Docket Number:	16-AFC-01C
Project Title:	Stanton Energy Reliability Center - Compliance
TN #:	228809
Document Title:	STAFF APPROVAL OF PROPOSED CHANGE
Description:	The project owner proposes to use a 2.64-acre primarily vacant parcel located adjacent to the SERC project site as an additional area for construction material storage, equipment laydown, and personnel parking
Filer:	Raquel Rodriguez
Organization:	California Energy Commission
Submitter Role:	Commission Staff
Submission Date:	6/21/2019 8:33:59 AM
Docketed Date:	6/21/2019

STAFF APPROVAL OF PROPOSED CHANGE STANTON ENERGY RELIABILITY CENTER (16-AFC-01C)

Project Description Figure 1

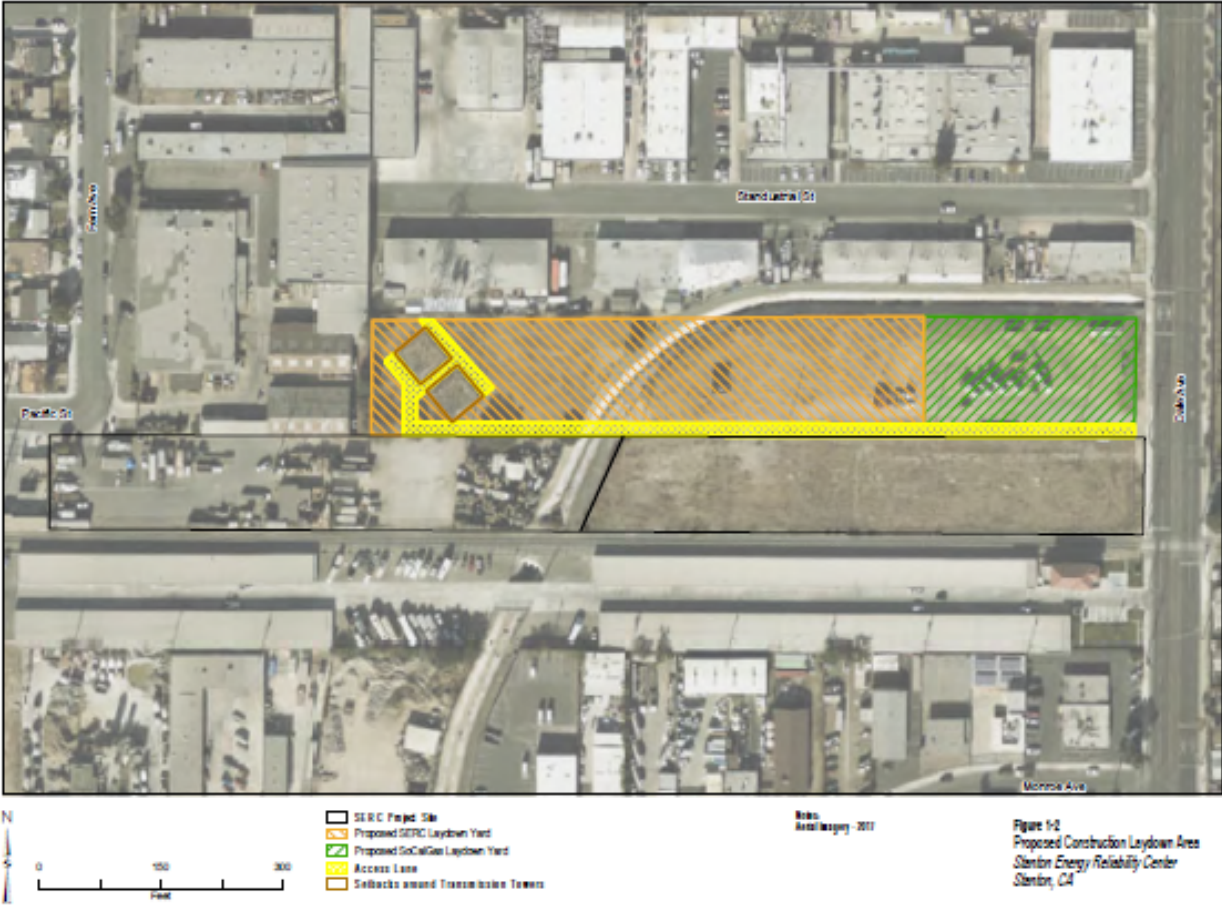
The project owner proposes to use a 2.64-acre primarily vacant parcel located adjacent to the SERC project site as an additional area for construction material storage, equipment laydown, and personnel parking. The parcel (Assessor's Parcel Number 126-591-16) is owned by Southern California Edison (SCE) and is a high-voltage transmission line right-of-way serving the nearby SCE Barre Substation.

The property would be used by the construction contractor hired by the project owner for construction of the SERC facility, and by Southern California Gas Company (SoCal Gas) for construction of the dedicated natural gas pipeline that will serve the facility (see **Project Description Figure 1**). Part of the area to be used by SoCal Gas was described to the Energy Commission during licensing. This petition seeks to add additional area to the SoCal Gas portion previously described.

The project owner has designated a roadway 16 feet wide along the southern boundary of the laydown parcels to provide access to two SCE transmission towers on the western portion of the parcel. By agreement with SCE, a 50-foot x 50-foot buffer area would be established around each of the two tower bases on the western parcel. Concrete k-rails would be placed around the tower bases to protect these from inadvertent damage.

The portion of the laydown area furthest east and facing Dale Avenue would be used by SoCal Gas as they construct the natural gas pipeline to the facility. This portion would now cover 0.9 acre rather than the 0.5 acre described in the Decision. The remaining 1.74 acres would be for used for facility construction. A temporary fence would be erected to separate

these two areas. Two 16-foot-wide gates would be placed into this fence: one in the western area and one in the eastern area.
